SHIRE OF SHARK BAY

TENDER # 2024/2025-01 Construction of
Denham Foreshore Revetment
FILE # CM00074

REQUEST FOR TENDER:	Construction of Denham Foreshore Revetment
TENDER NO:	RFT 2024/2025-01
ADDENDUM NO:	2
DATE OF ISSUE:	27 August 2024
NO. OF PAGES:	2

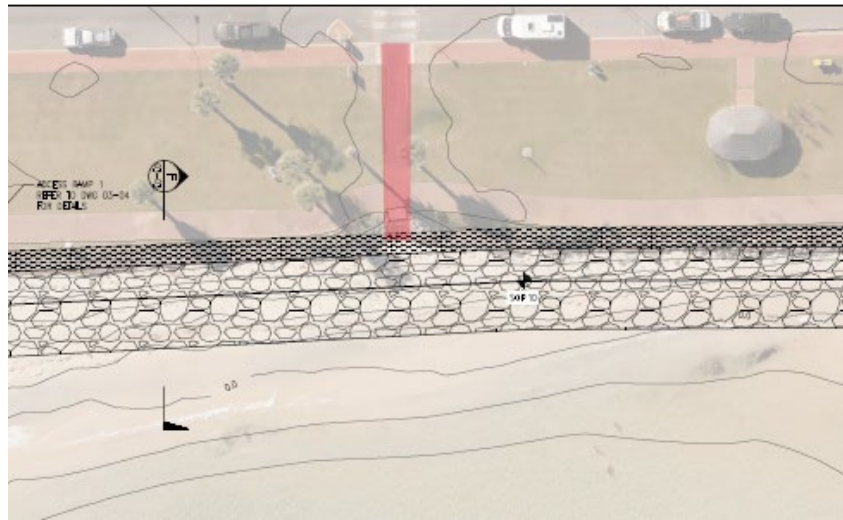
- There are two paved/ kerbed, accessways / open-drains in Work Area 2 (See below). These will no longer function with the proposed new revetment design. Is this the intended outcome? **The updated drawings note the requirement to locally modify the elevation of the seawall crest along the alignment of the two open drains to ensure that the drains continue to function.**
